CALIFORNIA COASTAL COMMISSION

AMENDMENT REQUEST
STAFF REPORT AND PRELIMINARY RECOMMENDATION

Application No.: 6-96-44-A

Amendment: After-the-fact approval for the addition of eight, 11-foot high strobic fan units (air vents) on the roof of a 50-foot high building (replacement Ritter Hall building) and modification of the approved landscaping plan.

EXHIBIT NO. 2
 APPLICATION NO.
6-96-44-A1
 Site Plan

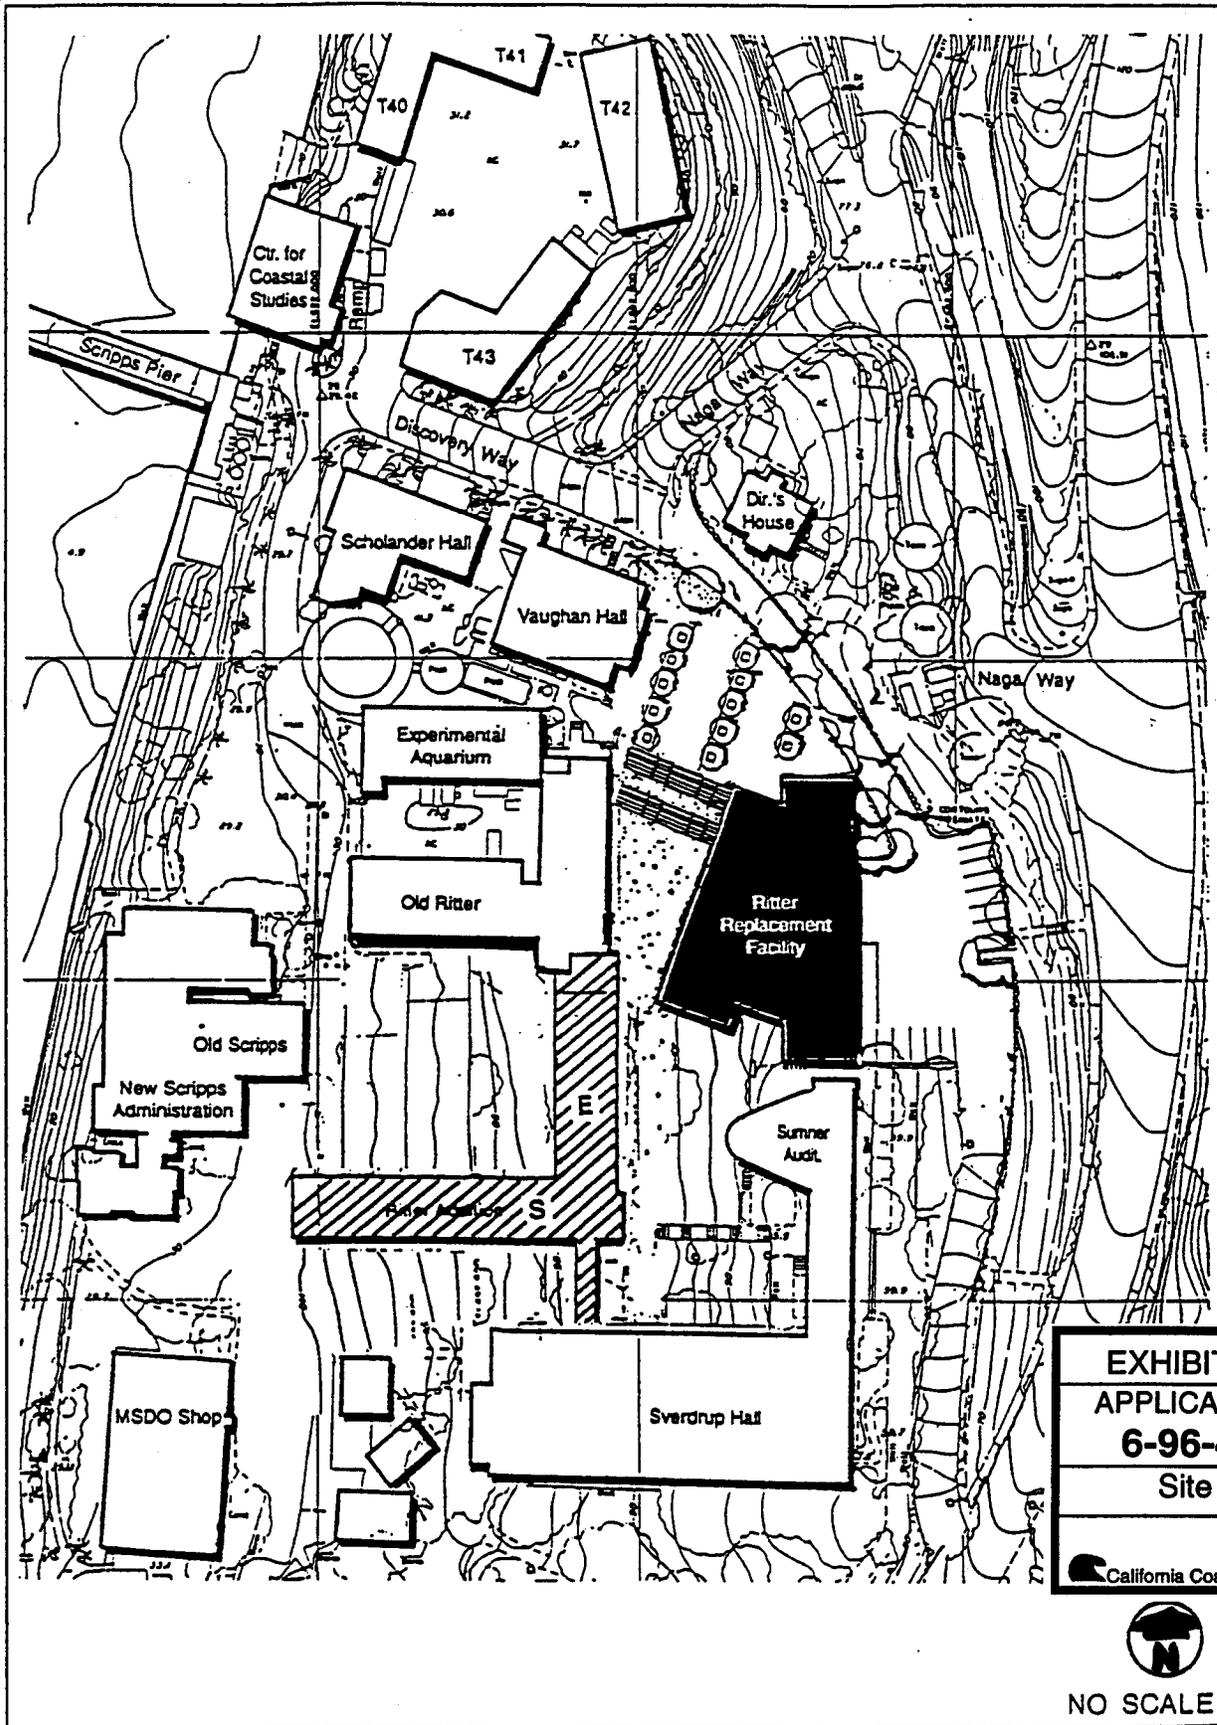
Commission staff drove this roadway and checked several public vantage points available from the roadway including the back patio of the Steven Birch Scripps Aquarium to determine if the fan units severely impacted public views of the ocean or of the viewshed from the scenic roadway. The strobic fan units were not visible from any portion along this roadway while traveling south or from the aquarium property. The units were also not visible from any portion of the public beaches to the west due to both the presence of other existing SIO structures between the subject building and the shoreline, as well as due to the fact that the terrain of this area slopes down in elevation from the roadway to the west. Views were also checked from La Jolla Cove across the ocean to the southwest looking at the project site. Although the subject building itself was visible, it was not possible to see the strobic fan units on top of the structure and there is a proliferation of many other structures in this viewshed on the SIO campus as well as residential development on the hillsides behind it. The fan units are most visible only immediately in front of the existing building while passing it by both motorists, pedestrians, bicyclists, etc. While walking along the roadway in front of the building, portions of the fan units on the rooftop were blocked by existing mature trees to the south of the building as well as a large tree to the northeast of the building.

As it was noted that some existing landscaping helped to buffer the fan units from public views from the scenic roadway, Commission staff asked the University if additional landscaping could be installed. The University indicated that a lot of the landscaping that previously existed on the subject site was removed during the construction of the building. Therefore, as part of the subject amendment, this landscaping is proposed to be replaced. In addition, portions of the project site will also be landscaped in connection with another coastal development permit that was recently approved by the Commission (CDP# 6-99-25) for construction of a seawater tank in close proximity to the project site. The applicant believes that this landscaping will also help to reduce the visual impact of

- a. A plan showing the type, size, extent and location of all trees on the site, to consist of, at a minimum, one tree for every ten feet of street frontage (minimum 24-inch box) and other shrubs that will visually screen the stoic fan units on the roof of the Ritter Hall Replacement building from the adjacent scenic roadway (La Jolla Shores Drive).

EXHIBIT NO. 3
APPLICATION NO.
6-96-44-A1
Revised Design for Strobic Fan Units
 California Coastal Commission

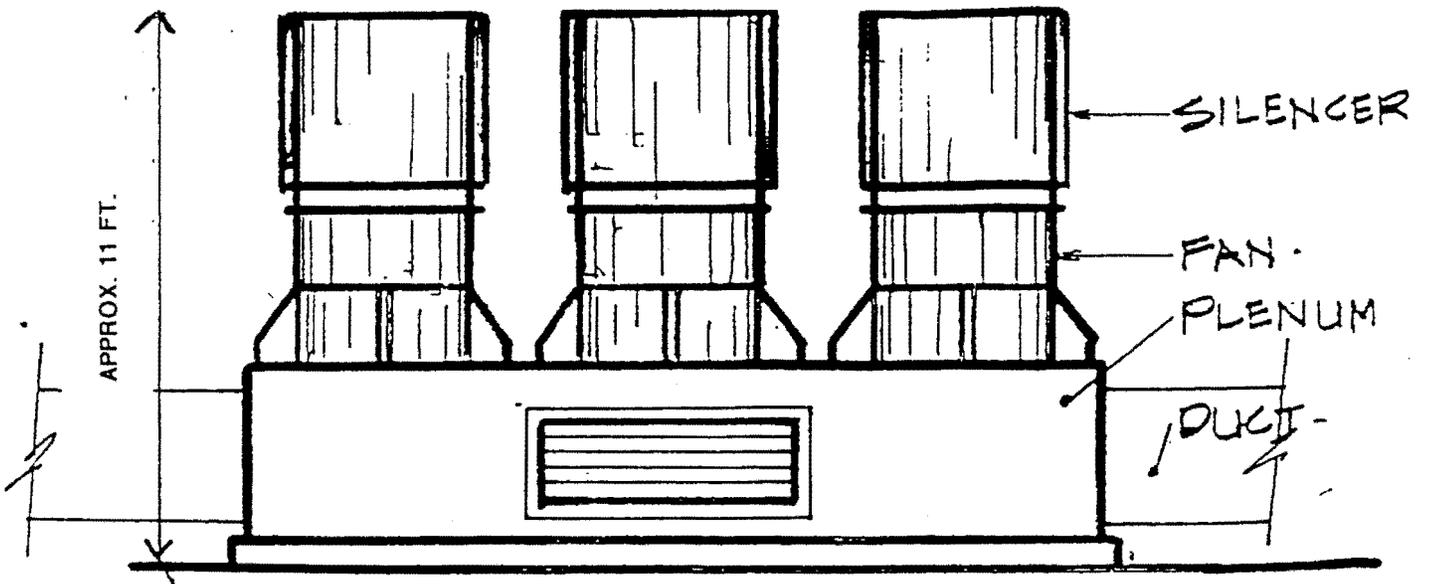
5) Reduce height of strobic fan units by system modification. – This was the option chosen by the University because it would maintain the system operational design and efficiency of the units and the visual impact would be significantly reduced.

In response to these questions, the University indicated that that any discharge location below the roof of the building would not produce the code-required air mixing so relocation of the units was not a feasible option. With regard to the second question, the University indicated that there was no known technology other than the strobic fan units or traditional fume hood vent pipes that would provide the same function. Vent pipes would be more numerous and would result in a greater visual impact than the existing configuration. Another consideration would be to gather all of the exhaust from the building and duct to another location but this would require an additional discharge tower above the height of the building and might also require additional equipment on the building roof for necessary air movement. With regard to the third question, the University indicated that if a different system were used or if the discharge point for any system was changed, the building would need to be re-ducted and structural modifications to the building might be required for the new duct work. It was also possible that certain structural requirements for the building might preclude a different duct routing. With regard to the fourth question, the University stated that all of the space in the building has been purpose-designed for a particular use. Also, adjacent building uses are coordinated. For example laboratory use is supported by office use and support uses. One use cannot be relocated to another building without there being a serious secondary impact on campus function. As such, the applicant has determined that other than reducing the height of the fans from 18 ft. to 11 ft., the fans must remain.

If these fan units been shown on the building plans when the project was first being reviewed by Commission staff, they would likely have not been approved due to their degree of visibility. As originally built, they were extremely visually obtrusive. However, the University has since lowered their height to 11 feet (reference Exhibit No. 3) which has significantly reduced their visual impact. Although the project site is not located within any designated view corridor in the certified LCP, it is important to note that La Jolla Shores Drive is designated as a scenic roadway in the certified La Jolla-La Jolla Shores LCP. Panoramic ocean views are visible from the northern portion of the roadway as it descends in elevation to the south.

EXHIBIT NO. 4
APPLICATION NO.
6-96-44-A1
East Elevation
 California Coastal Commission

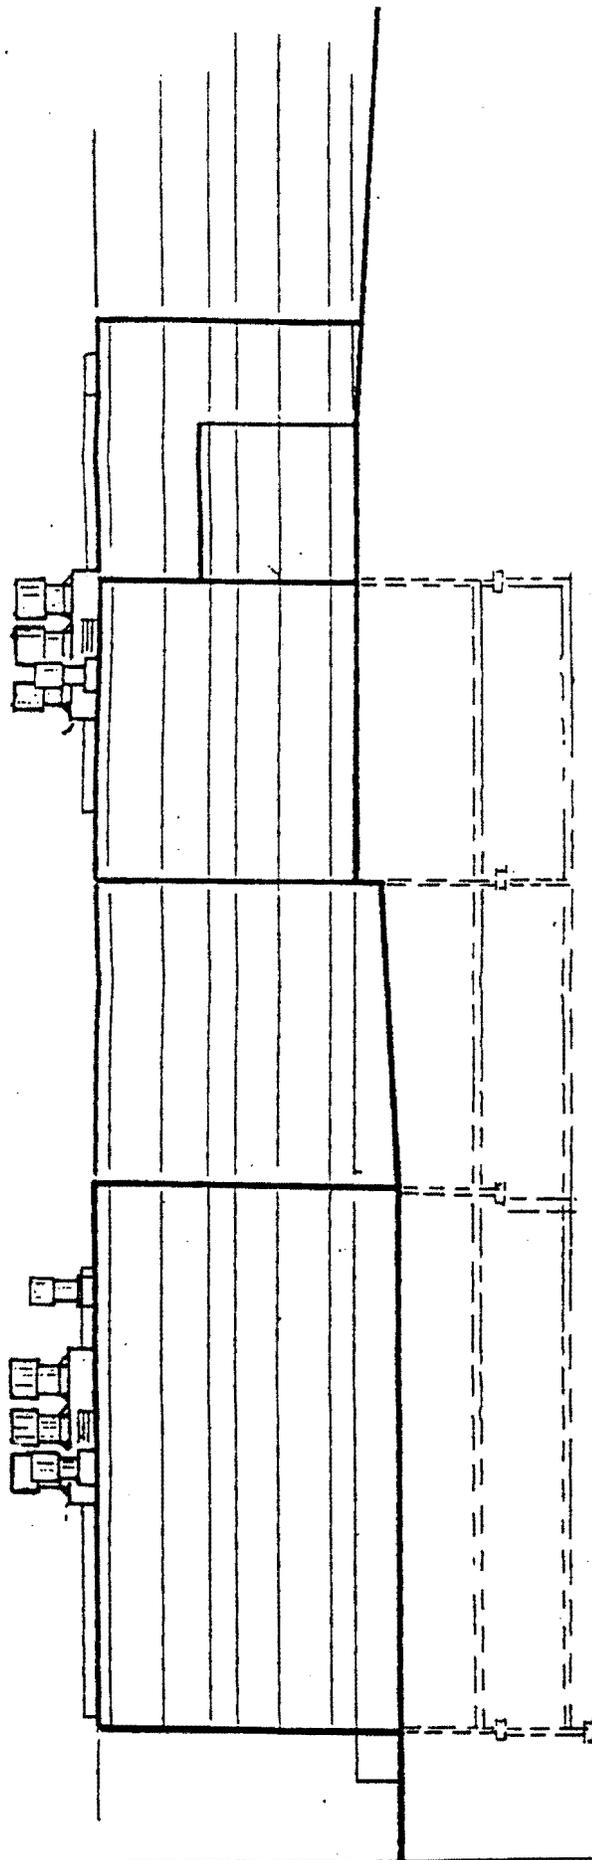
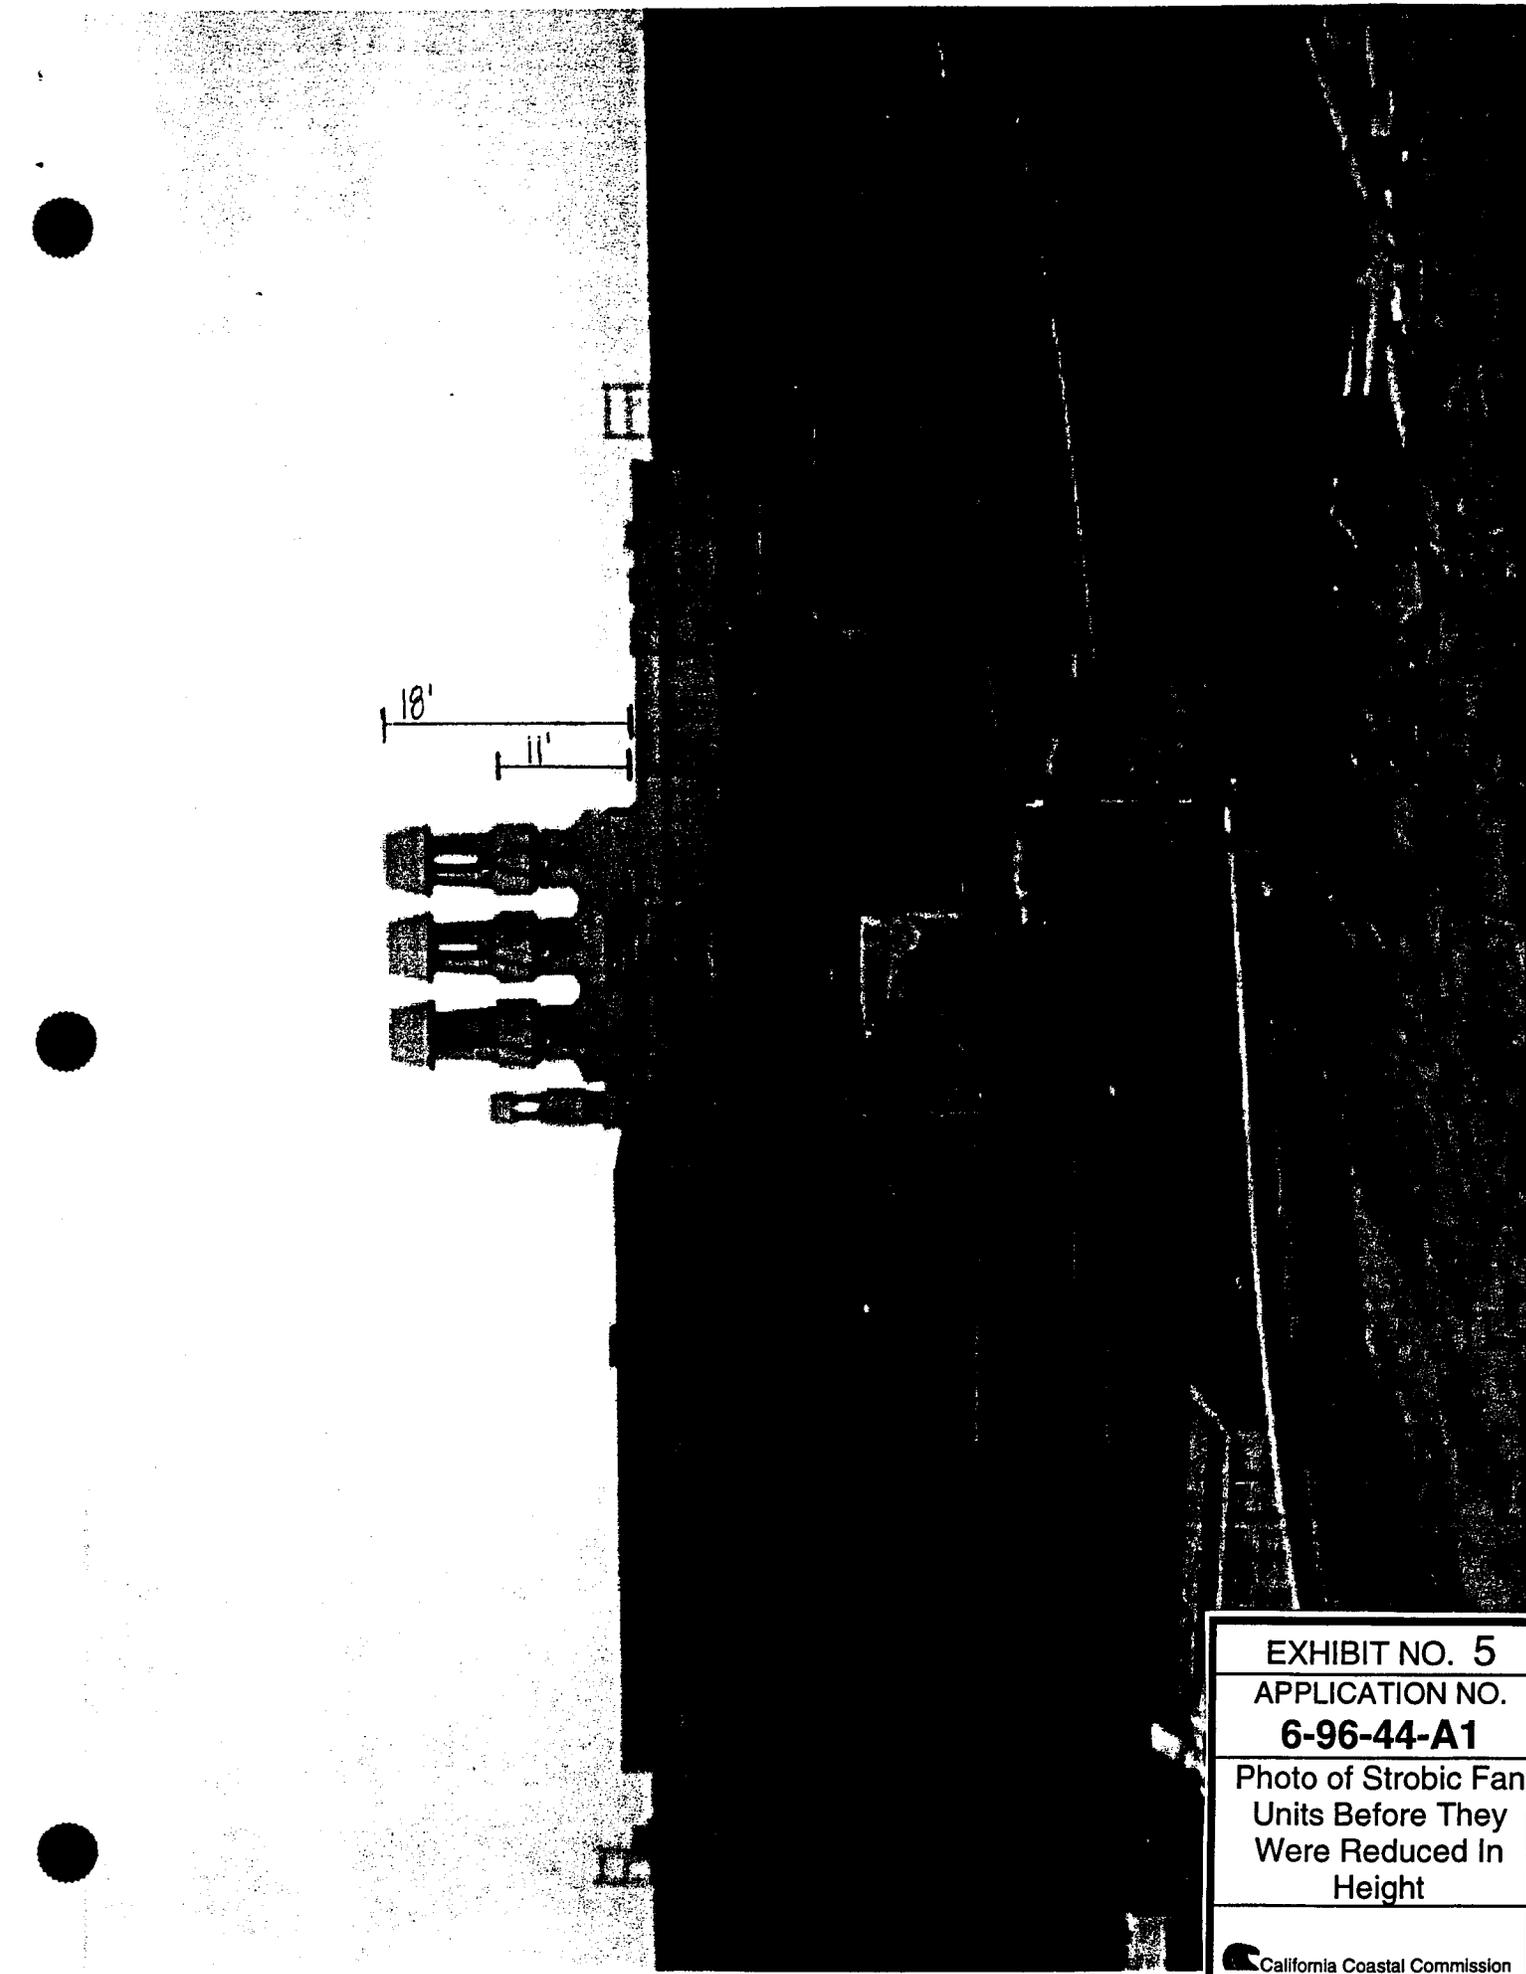
As noted previously, La Jolla Shores Drive, where the project site is located, is designated as a scenic roadway in the certified La Jolla-La Jolla Shores LCP. The proposed amendment, to retain the existing strobic fan units on top of an existing three-story structure previously approved by the Commission represents a potential adverse impact to the viewshed of this scenic roadway.
